Oconee Nuclear Station

Standby Shutdown Facility (SSF)

Flood Barrier Breach Violation

informal reassessment

SSF Wall Relative Heights of Flood Barriers and Penetration

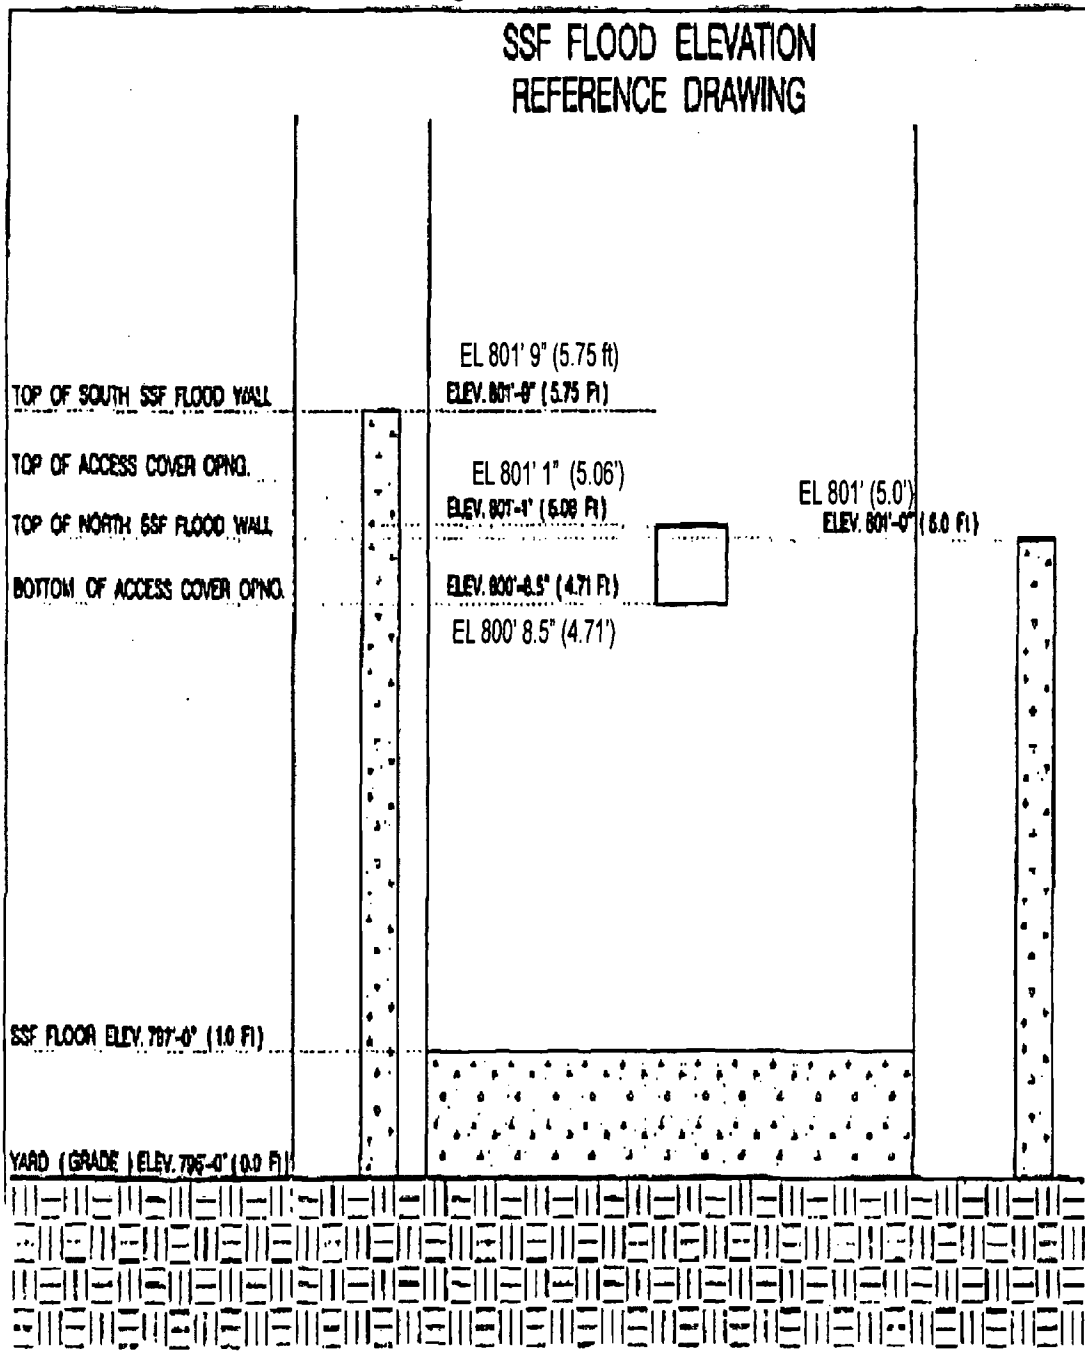
- Open penetration access cover in the SSF exterior wall for approximately 2 years.
- No 50.65(a)(4) evaluation done by licensee.
- Opening below 5-ft max. flood height identified by licensee in IPEEE.
- Susceptible to site flooding from rupture of Jocassee Dam 11-miles upriver.
- Region II SRA performed analysis based on information from the licensee and apportioned flood height based on split fractions to arrive at a quantitative WHITE finding.

- Does a 3.5-inch change in flood wall height that last for longer than a year result in an increase in core damage frequency greater than $1\text{E-}6$?
